**RE: RESPONSE TO INFORMATION REQUEST – DEVELOPMENT PERMIT FOR MATERIAL
CHANGE OF USE FOR EMERGENCY SERVICES AT 43 FRONT STREET, MOSSMAN
COUNCIL REF: MCUC 2026_5947/1**

Reference is made to the abovementioned development application and Council's Information Request dated 26 June 2026. In accordance with Section 13.2 of the Development Assessment Rules, we hereby provide a full response to all matters raised, and request that Council proceed with assessment of the application.

Figure 1 – Current kerbside refuse collection

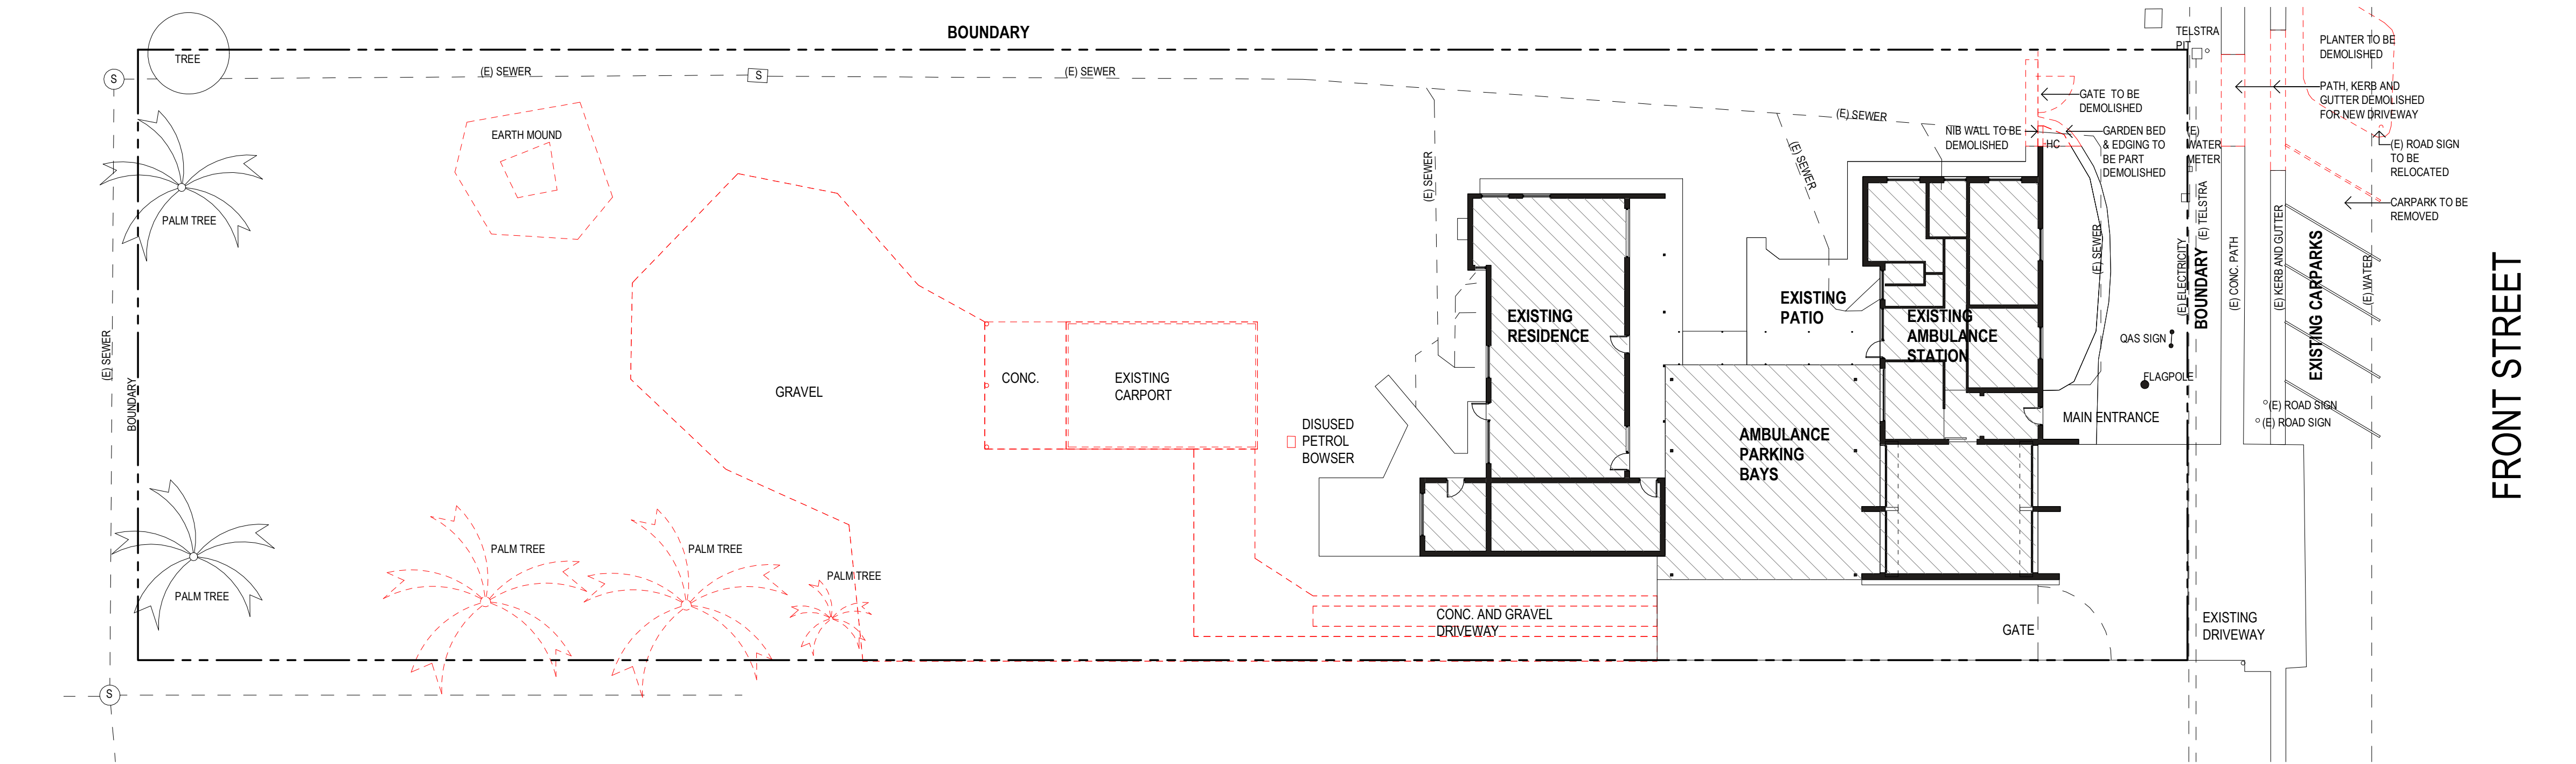
2. It is proposed to utilise the current waste arrangements for the site which include:
 - a. General waste bins to be collected from the kerb (see **Figure 1**); and
 - b. Medical waste (consumables) to be disposed of in accordance with legal requirements by licenced contractors.

The current and proposed facility are expected to generate the same amount of waste which is similar to that generated by a household.

1 EXISTING & DEMOLITION SITE PLAN
A201 1: 200

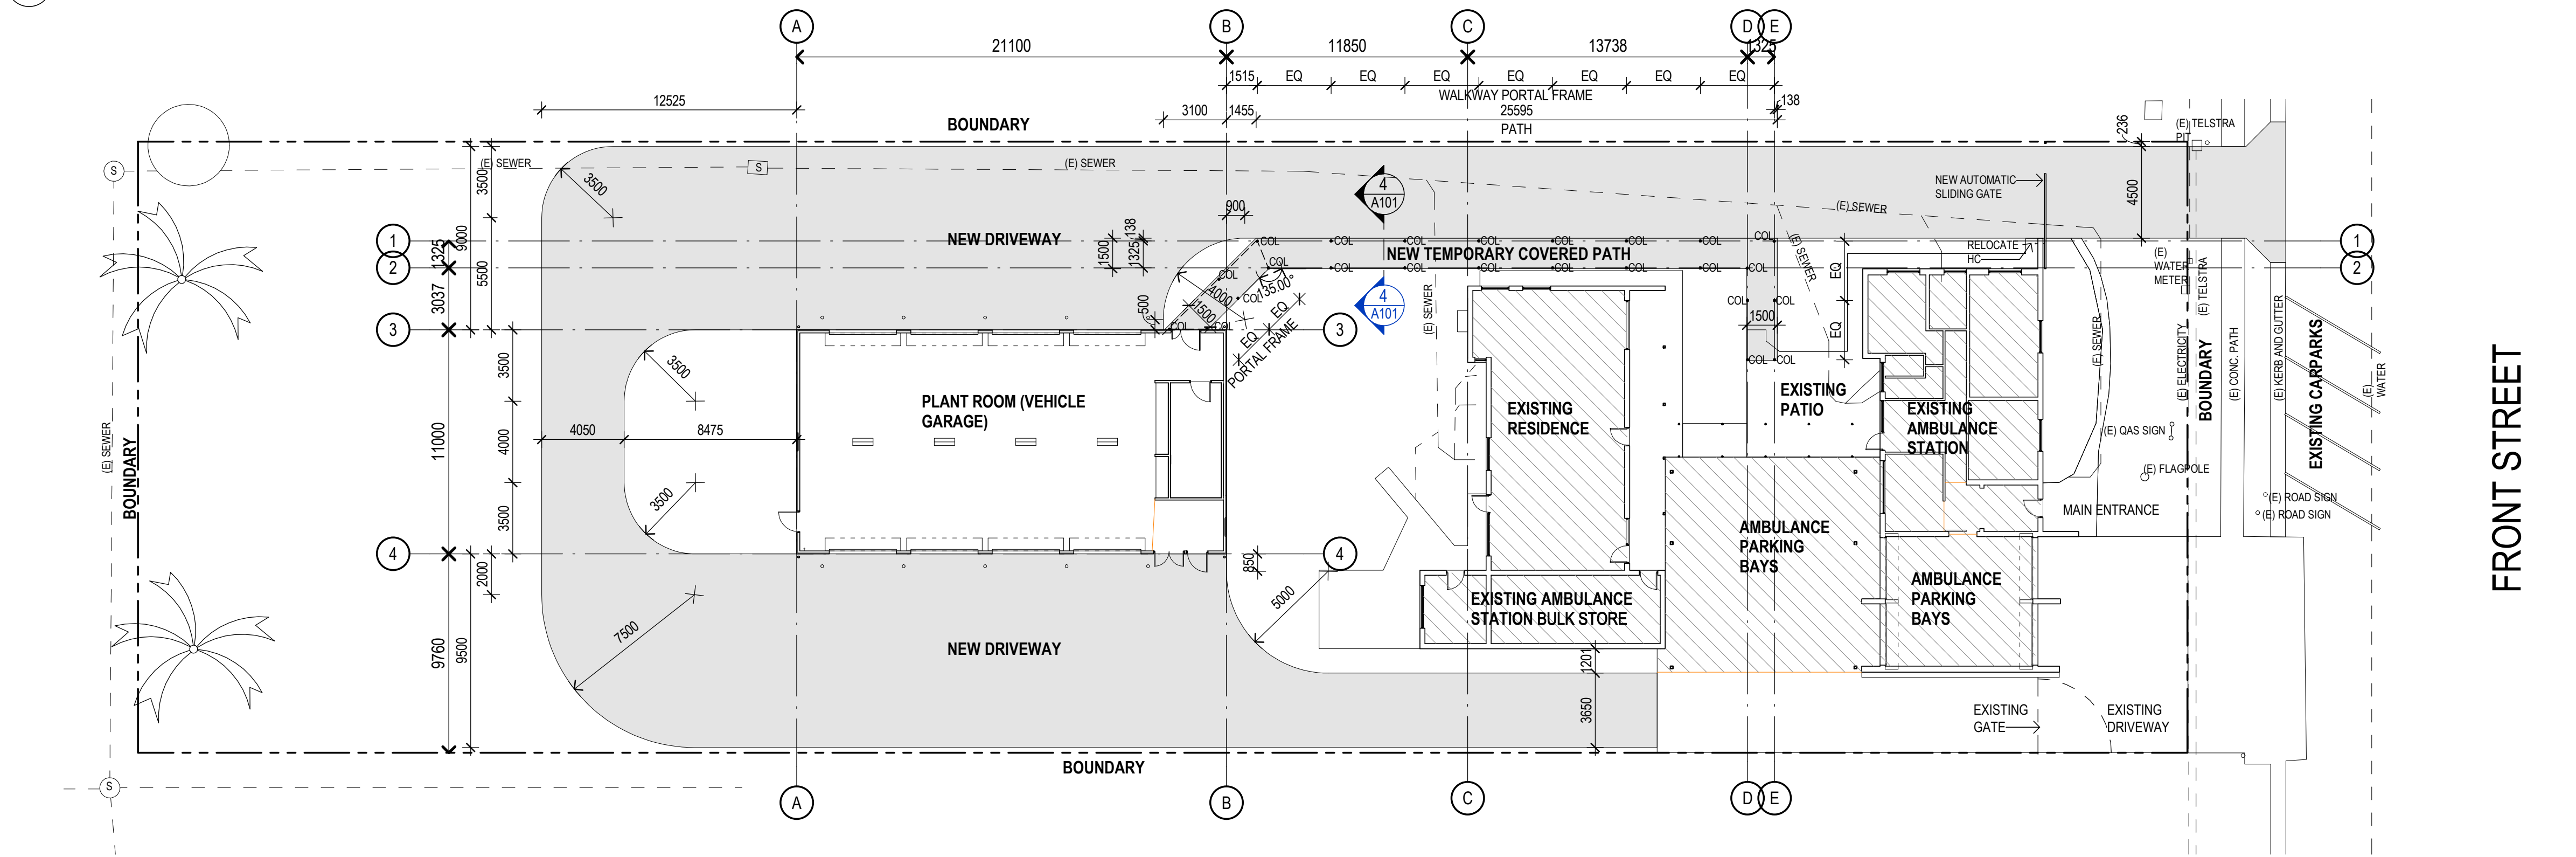
3. Please see attached Existing Floor Plans which show the existing floor areas. The existing enclosed floor areas are listed below:
 - a. Existing ambulance station (including enclosed ambulance bays) – 133m²
 - b. Existing residence and bulk store - 123m²
 - c. Existing plant room - 195m².
